PCB Power Relays G2RL-2 series

Information of Product Code Change according to country origin change.

Effective as of September 1, 2013 (G2RL-2 series)

G2RL-1-E made in JAPAN

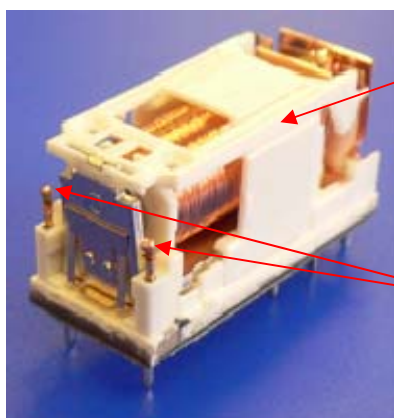
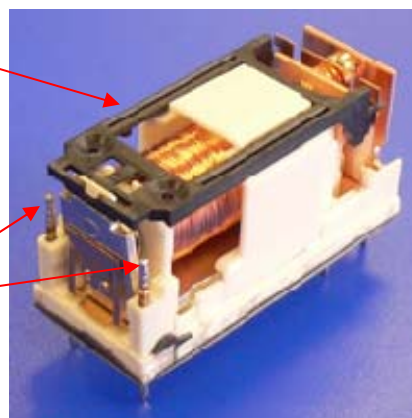
Before the change	After the change
<p>1. Name of production factory OMRON RELAY & DEVICES Corporation (JAPAN)</p> <p>2. Indication of Lot Number ****Y1 (****: Production date Y1: Production factory code)</p> <p>3. Material color in the internal parts (CARD) WHITE [Fig.1 item A]</p> <p>4. Connection way between magnet wire and coil terminal WELD [Fig.1 item B]</p>	<p>1. Name of production factory OMRON MALAYSIA SDN. BHD. (MALAYSIA)</p> <p>2. Indication of Lot Number ****W1 (****: Production date W1: Production factory code)</p> <p>3. Material color in the internal parts (CARD) BLACK [Fig.1 item A] (the same material as Japan)</p> <p>4. Connection way between magnet wire and coil terminal SOLDER (Pb free) [Fig.1 item B]</p>

※Above picture is example of G2RL-1 series, Changes of G2RL-2 series is same as G2RL-1 series.
